URGENT FIELD SAFETY NOTICE

GE HealthCare Ref. # 39004

RE: **TruSignal SpO2 Sensors – potential reduction of energy reaching patient during defibrillation, potential contact with unintended voltage, or inaccurate measurement**

Figure 1: Defective TruSignal Adult/Pediatric Sensor with material blocking emitters and detectors.

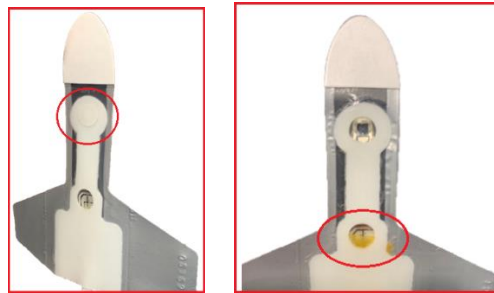
Affected TruSignal Adult/Pediatric SpO2 Sensors (see Table 1 below) may contain additional material that can block the emitter or detector areas potentially leading to an inaccurate SpO2 reading, which could contribute to an adverse patient outcome.

1. Before using Adult/Pediatric SpO2 Sensors (see Table 1), confirm that the sensor does not contain additional material covering the emitter or detector (See Figure 1).
2. If any additional material is present, discard the sensor and select another sensor. (An image of a non-impacted TruSignal SpO2 Sensor is shown in Figure 2.)
